MAJOR PROJECT ASSESSMENT
Kerosene Vale Stage 2
Ash Repository Area

**Director-General's Environmental
Assessment Report**
**Section 75I of the *Environmental Planning and
Assessment Act 1979***

November 2008

Figure 4: Proposed Realignment of Sawyers Swamp Creek
(Parsons Brinckerhoff, 2008)

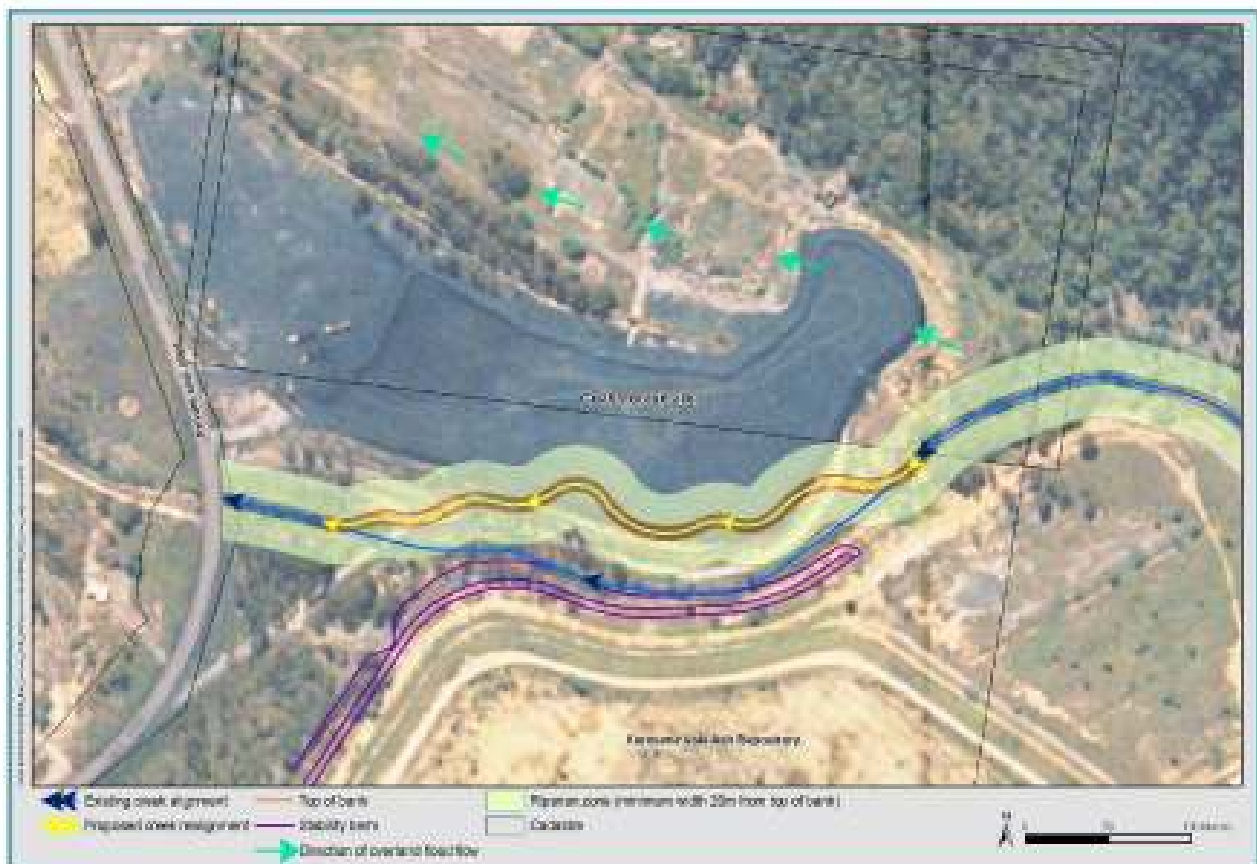
The DWE recommended the establishment of a 20 metre wide riparian zone on both sides of Sawyers Swamp Creek for its entirety within the site, consisting of local native plant species. It also requested that the conditions of approval require:

The SCA indicated that the Proponent should be required to incorporate in-stream structures in the reach upstream of the proposed realignment so that the proposed realignment and rehabilitation works are not compromised by upstream erosion. It also recommended that the Rehabilitation Plan for the creek include details of initial and ongoing weed control.

In regards to the SCA's recommendation to incorporate in-stream controls in the reach upstream of the proposed realignment, the Department has recommended a condition of approval requiring the Proponent to detail any proposed in-stream controls upstream of the creek realignment in the Rehabilitation Plan for the creek.

Figure 5: Potential Coal Sterilisation Areas

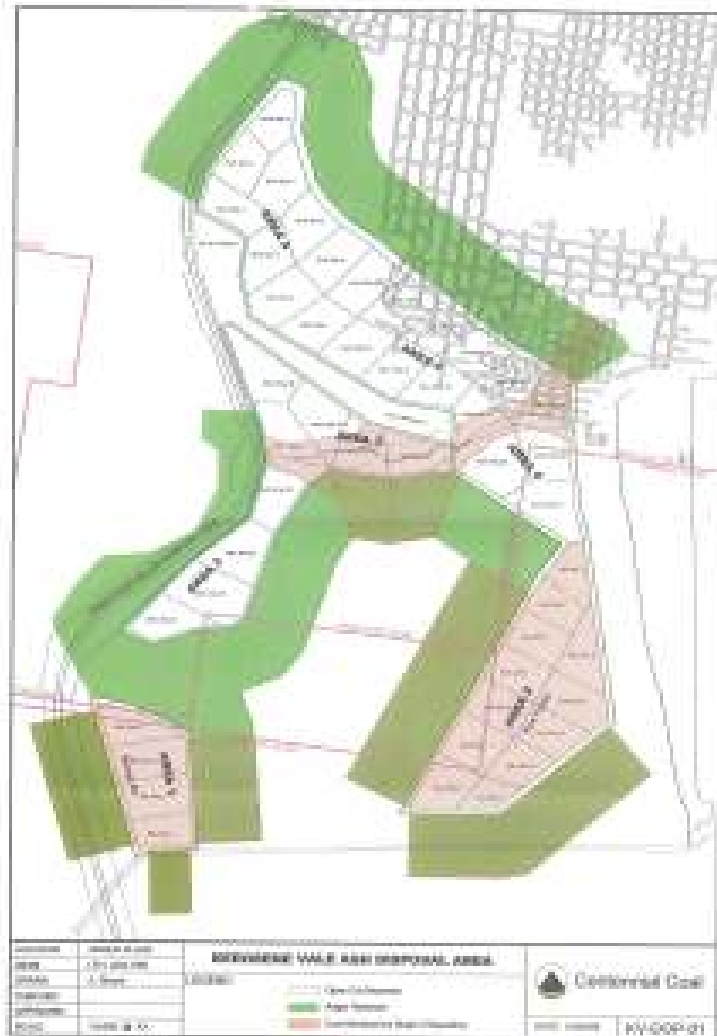
The DPI (CARA) noted the Proponent's commitment to stage activities to optimise the timeframe in which Centennial could access the remaining coal reserves, and indicated that the Department of Planning must consider coal sterilisation when determining the application.

Centennial noted that the extraction of coal could significantly increase the capacity of the Repository by five years or alternatively lower the design height while still maintaining the design life, and concludes with a request for a single Part 3A planning approval which addresses both ash emplacement and removal of coal within the project footprint.

The Proponent has committed to revised staging of ash placement to address concerns related to coal sterilisation and to provide time for Centennial to investigate the feasibility of mining in the area and obtain the necessary approvals. This would involve:

- deferral of the Sawyers Swamp Creek alignment until 2010 to allow Centennial time to seek approval for extraction activities in Areas 3 and 4 and avoid multiple creek realignments;
- modified surface water runoff and capture based on the modified ash placement activities; and
- reduced depth of excavation of the pine plantation area.

The Department considers that the proposed modified staging is a reasonable and feasible measure for providing Centennial with time for obtaining the necessary approvals for the extraction of coal within the location of the Repository. The Proponent's proposal to modify the staging has been reflected in the recommended conditions of approval which require ash placement activities to be managed in accordance with the staged placement activities detailed in the Submissions Report.
